**Before the Expert Panel appointed
under the Fast-track Approvals Act 2024**

an application for approvals by Mt
Iron Junction Limited to develop 250
medium to high density residential
dwellings, a childcare centre, a retail
building, a café, reserve areas and
recreation amenities

**Statement of Evidence of
Duncan Lawrence White on behalf of
Mt Iron Junction Limited in response to
comments made under Section 53**

Dated: 26 June 2026

PROJECT P240103
DRAWING NO 002
SHEET 000
REVISION 6
SCALE (A3) N/A

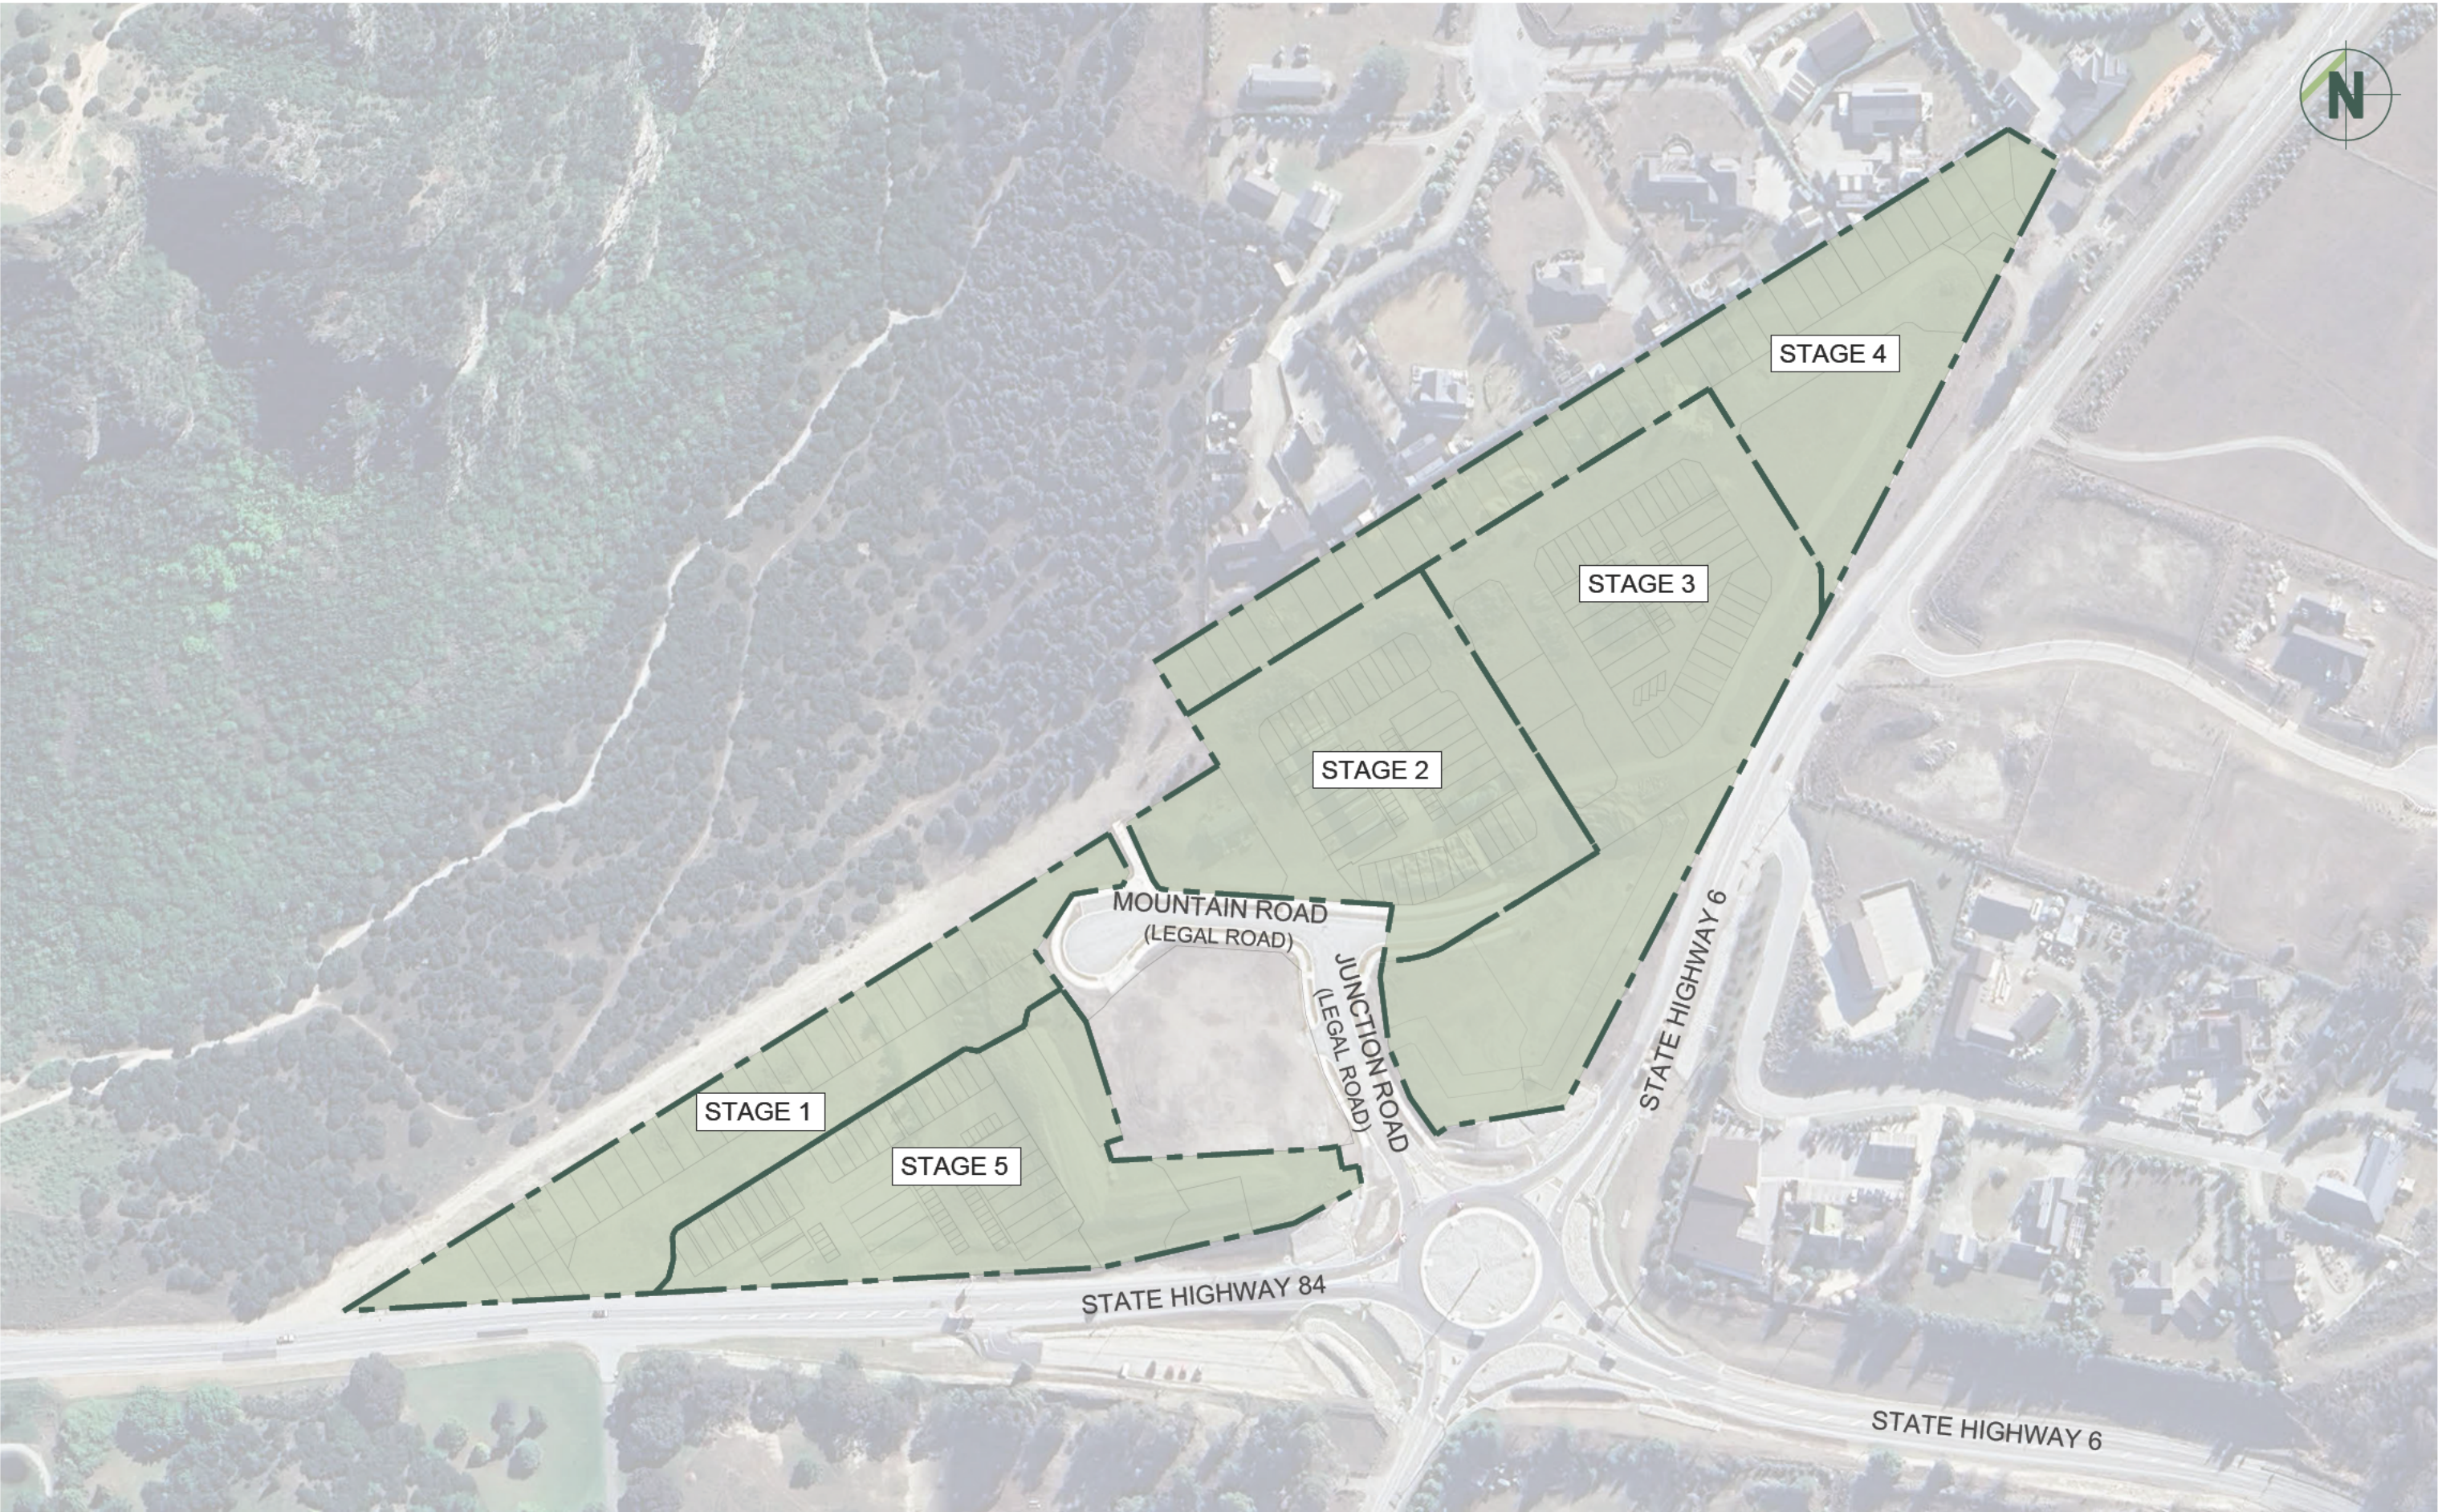
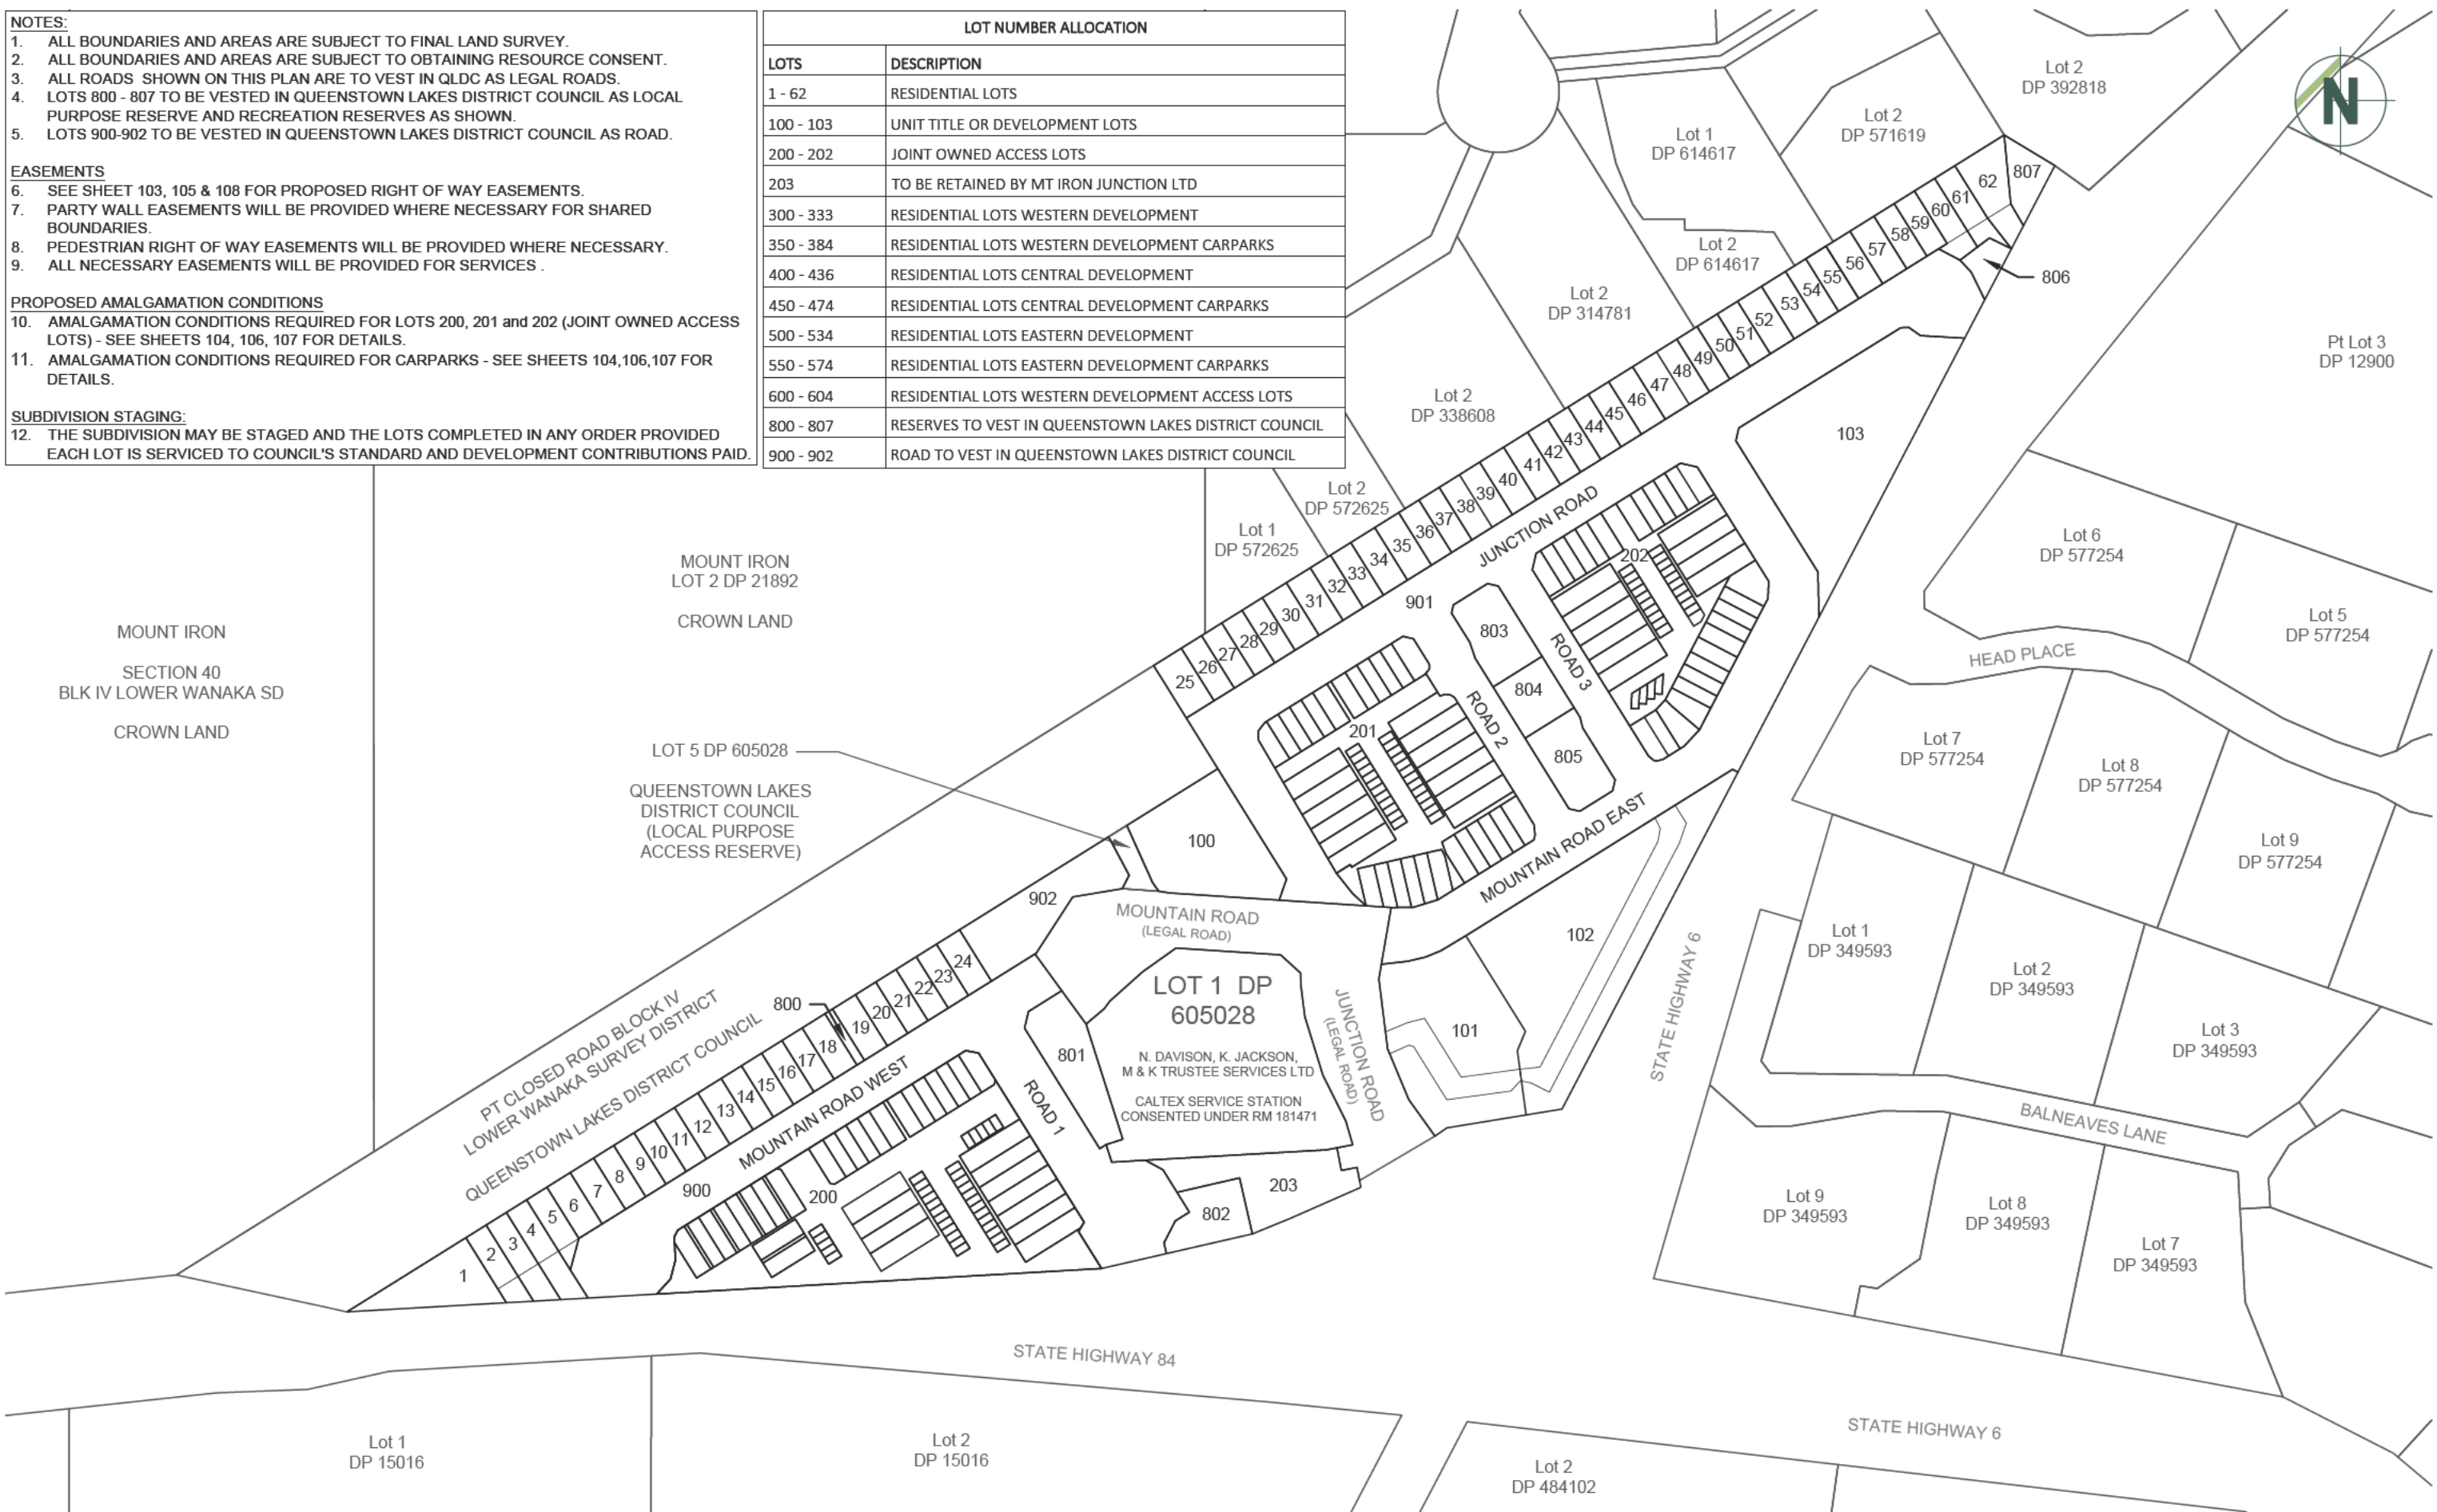
63. Paras 1.4, 4.5.4 and 4.5.7.4 of Ms Overton's Development Engineering memo notes that Lot 203 is shown as a Jointly Owned Access Lot in the right hand table on Sheet 100 but is not amalgamated with any other lot. The inclusion of Lot 203 in the table as a Jointly Owned Access Lot is incorrect as Lot 203 is not intended to be a jointly owned access lot, it is intended to remain in the ownership of Mt Iron Junction. An updated scheme plan set is appended to this evidence (**Appendix E**). As this change is a revision the entire scheme plan set has been updated to Revision 6, although the only change has been to remove reference to Lot 203 as a Jointly Owned Access Lot and include it in a separate row of the table to be retained by Mt Iron Junction. Lot 203 is not proposed to be amalgamated with any other lots so does not need an amalgamation condition.

49.	Amalgamation conditions as shown on the scheme plans as applicable at the completion of each stage are to be registered with Land Information New Zealand (CSN XXXXX)	Further clarification is required as to what JOAL Lot 203 will be amalgamated to	Discussed in evidence the plans are correct. Lot 203 is to be retained by Mt Iron Junction and not to be amalgamated with another lot so does not require an amalgamation condition. Have updated righthand table on Sheet 100 to correct. Updated scheme plan in evidence of Duncan White. Does not require a change to condition.
